**LEGAL ADVERTISEMENT
PORTLAND PLANNING BOARD
MEETING AGENDA**

Re: Revised MDP concept – topic discussion (transportation, parking, servicing and design)
Level III Master Development Plan
383 Commercial Street (Rufus Deering site)

At the October workshop the Board requested an in-depth discussion of transportation, servicing and parking issues and this Memo focusses on those subjects. The applicant has also submitted revised architectural plans and elevations and Board feedback on these would be helpful if time allows.

C-2.0

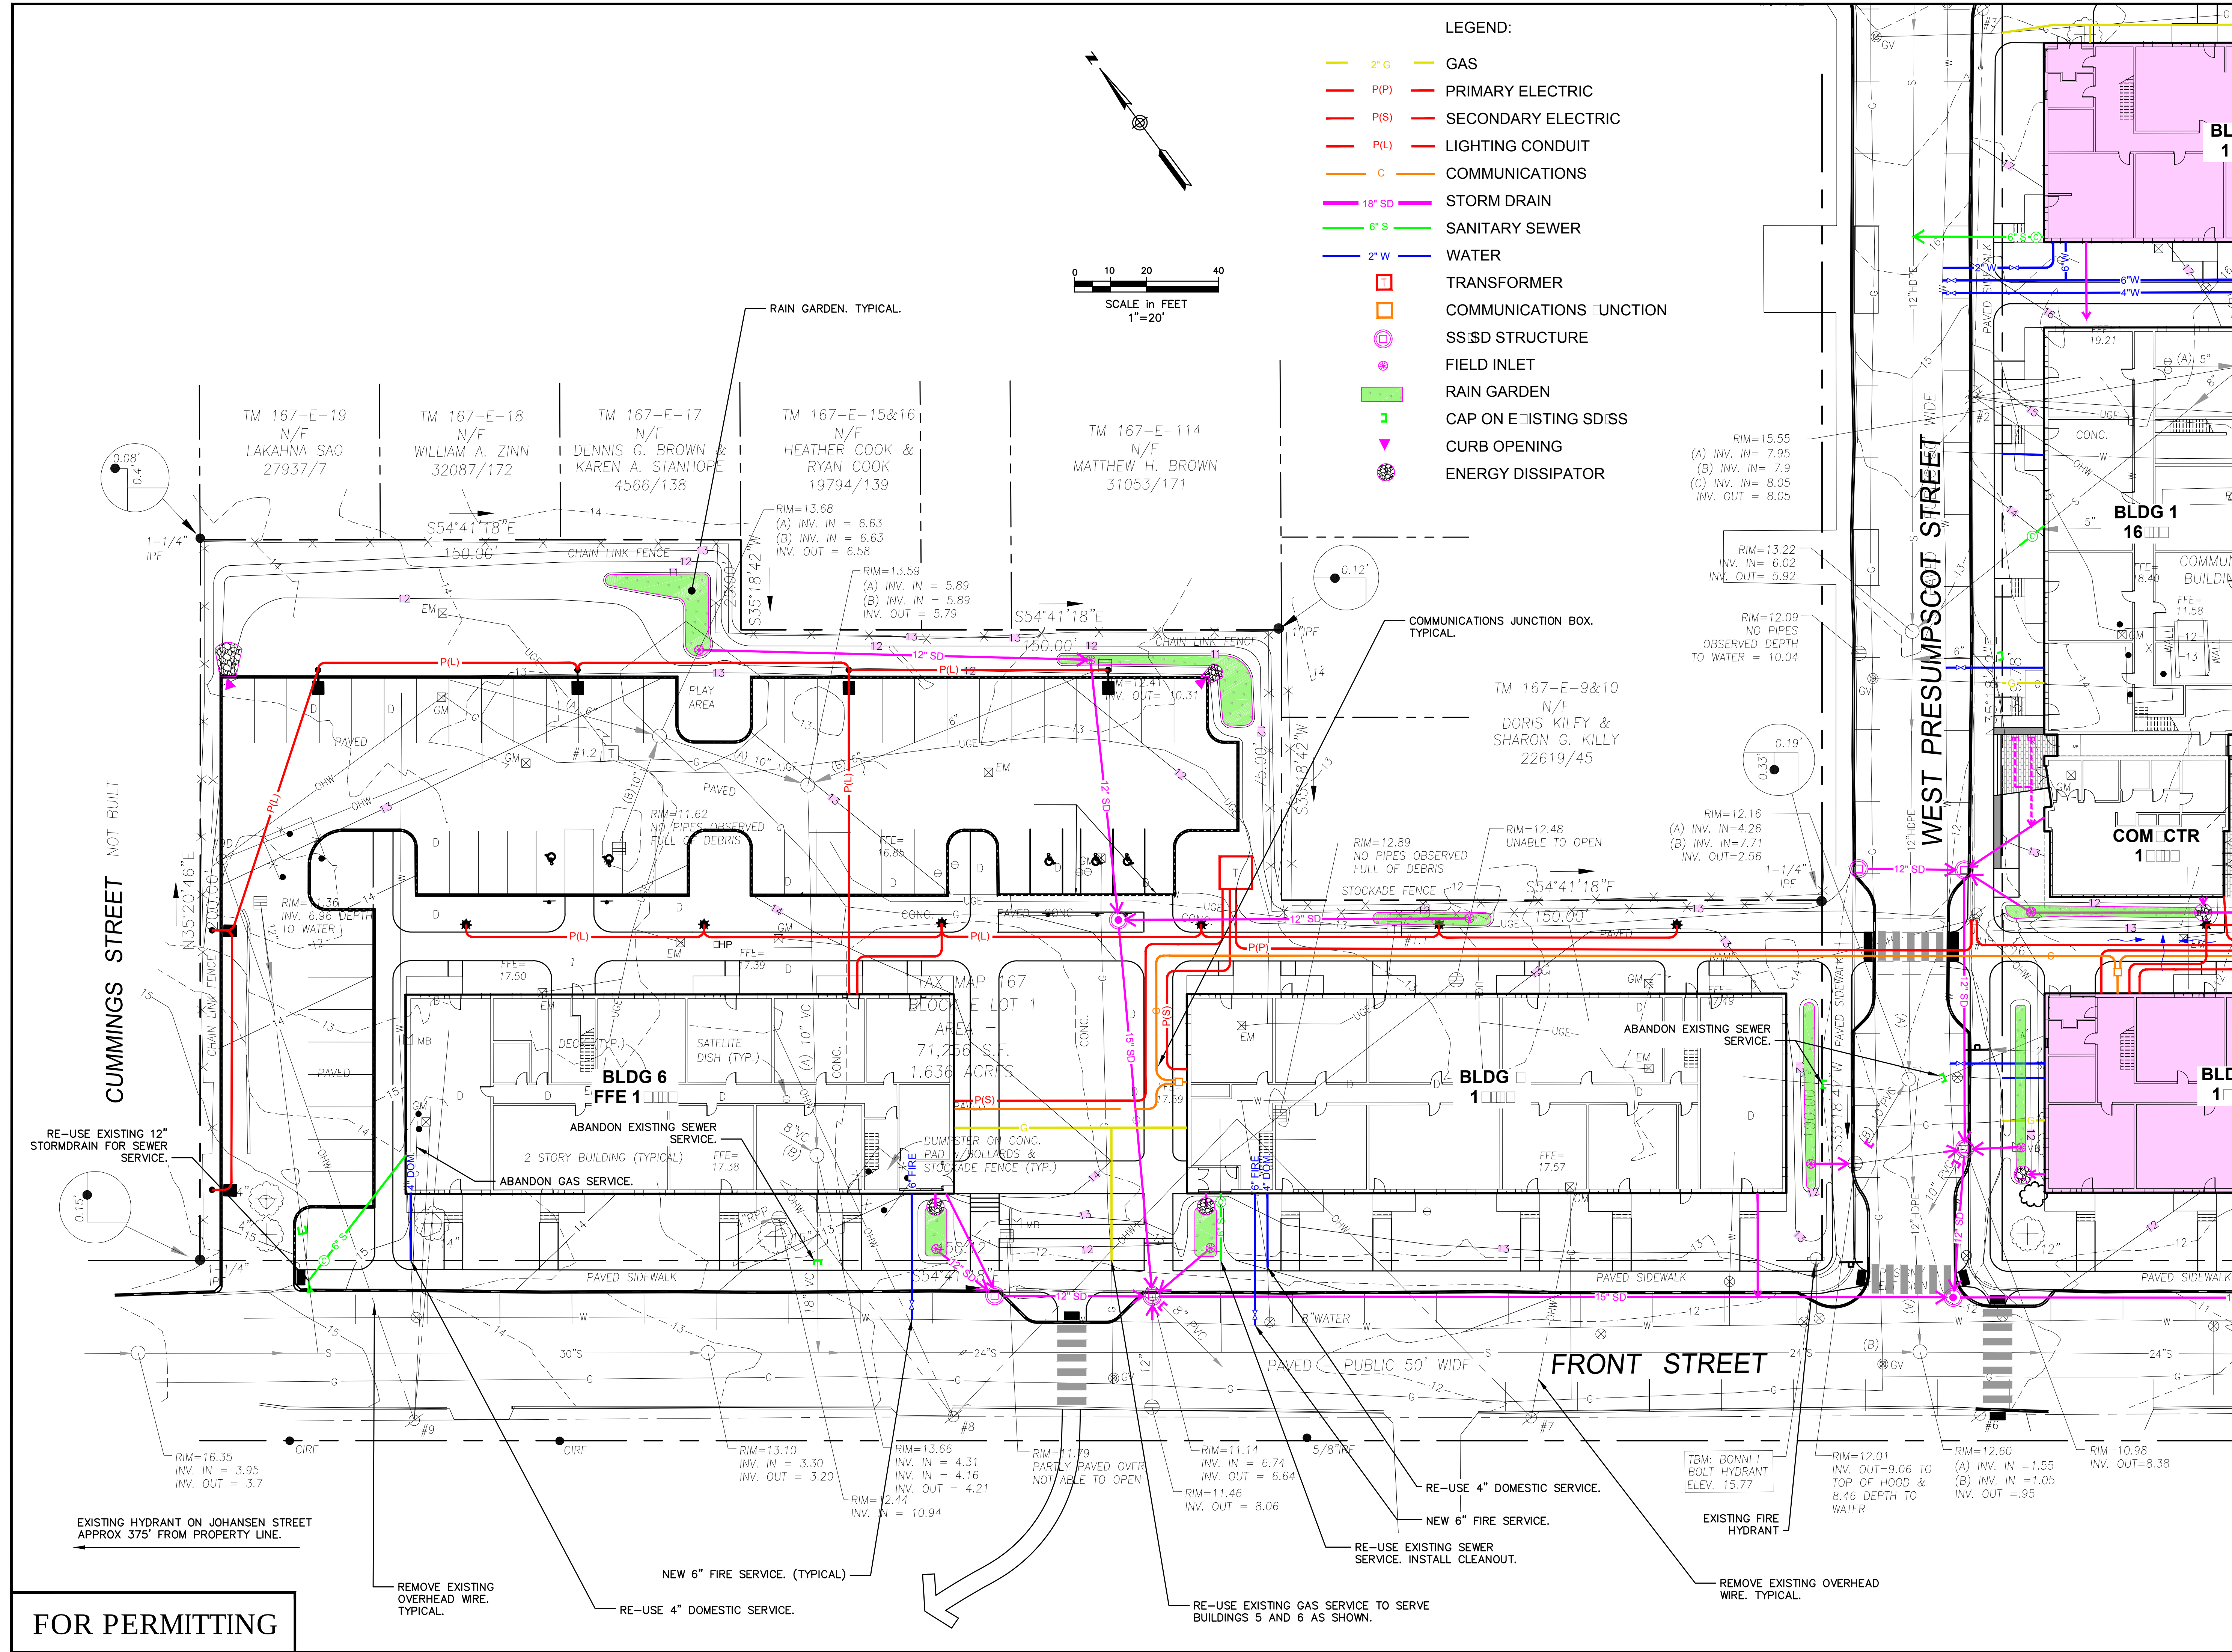
Sheet C-2.0 Site Plan

L-1.0

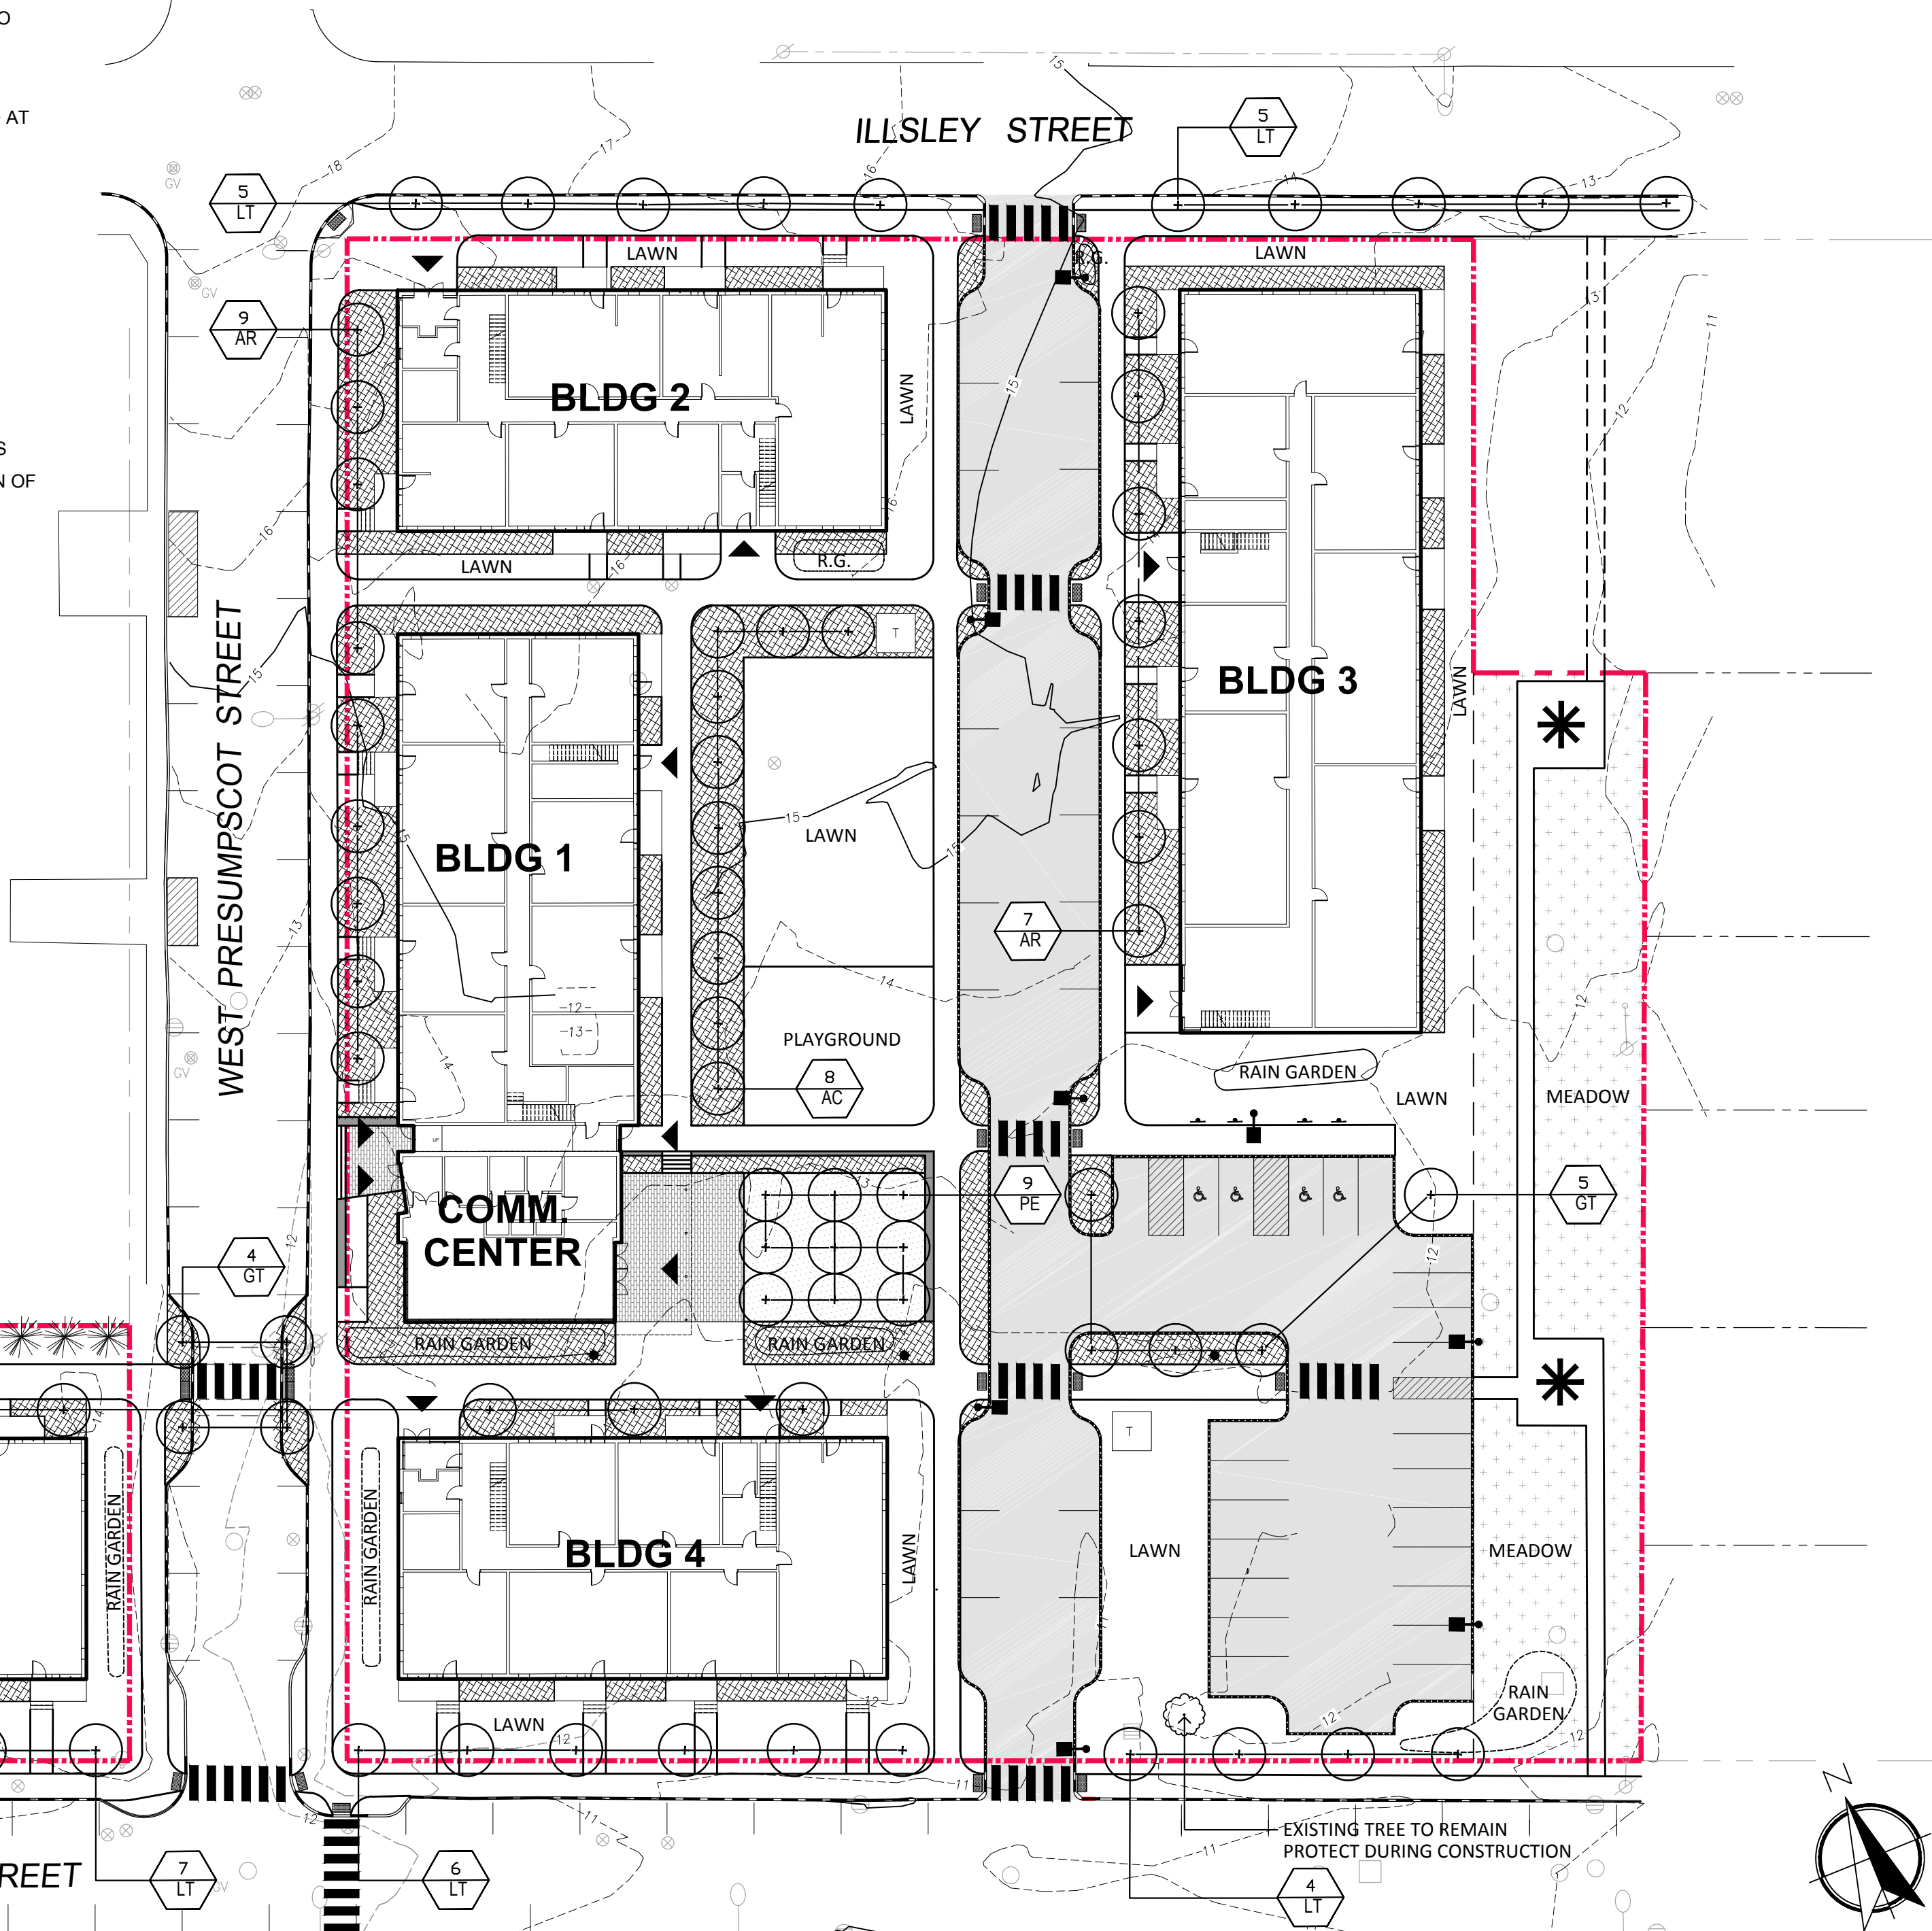
Sheet L-1 Landscape and Lighting Plan

- In conjunction with the Photometrics Plan (Sheet L-2), no lighting or lighting analysis/photometrics is shown along the Public ROW - particularly with the pedestrian crossing of West Presumpscot Street and the other public street crossings - please update the plans to show the location of other/existing lighting, focusing on those locations with pedestrian crossings- please note that the city has an LED light fixture replacement program for most cobra head lights in the city slated for 2018.
